ZAYO’S PRINEVILLE TO RENO PROJECT

CPUC MINOR PROJECT REFINEMENT FORM

Date Requested: 6 June 2025	Report No.: 19/RFI 512
Date Approved: 8/25/2025	Approval Agency: Caltrans, in addition to CPUC. Caltrans approval on 5/30/2025
Property Owner(s): Caltrans	Location/Milepost: MP L104 - L105
Land Use/Vegetative Cover: Ruderal (maintained highway shoulder near edge of pavement) with small wetlands and drainages.	Sensitive Resources: Cultural site determined significant outside of ADI only. Wetland at MP L104.3 avoided with HDD.

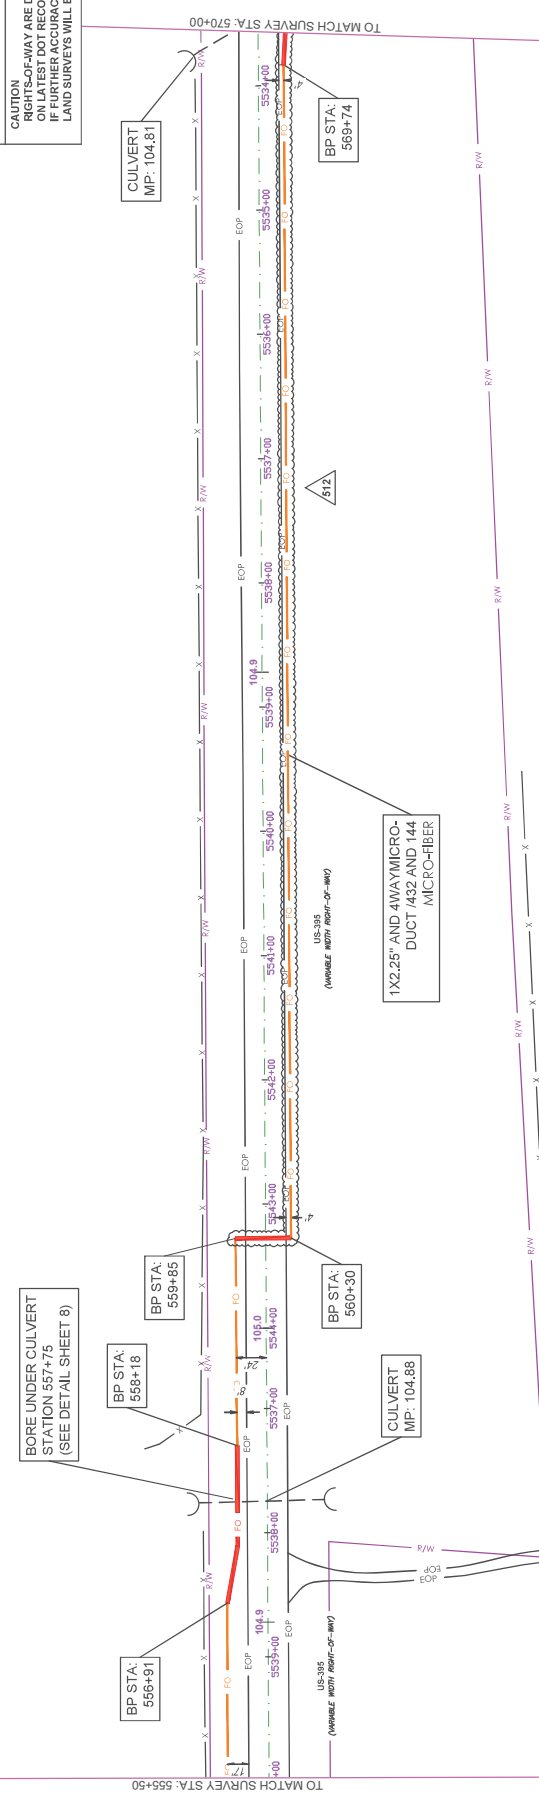
The proposed reroute is based on unanticipated cultural resource discovery. The reroute shifts the running line to a more disturbed portion of the cultural site boundary. Pending archaeological site testing, the proposed reroute is intended to avoid intact cultural deposits and will avoid requirement of additional mitigation requirements. Site testing is pending permit approval from the BLM state office, as well as tribal review and approval.

VIEWPORT - 46

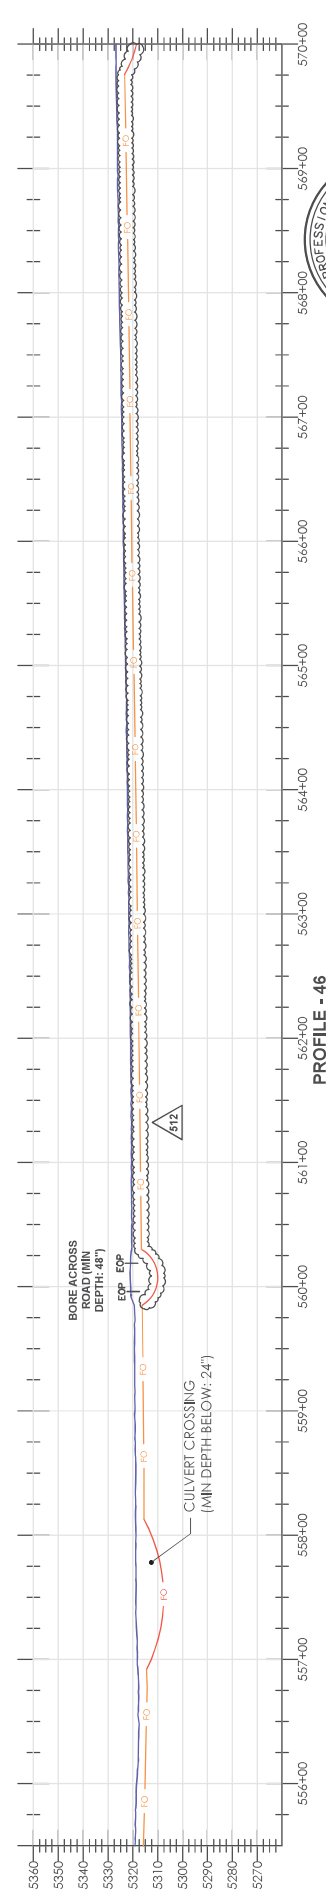
REF NO. 0812
MOVE RILEY 4 FEET FROM EOP
ON THE EAST SIDE OF THE ROAD
AT STA. 559+48 & BACK TO EAST
SIDE AT 584+08. MOVE HH TO THE
SOUTH END OF THE BORE OF THE
CULVERT AT MP. 104.81 AT 10 FT
FROM EOP.
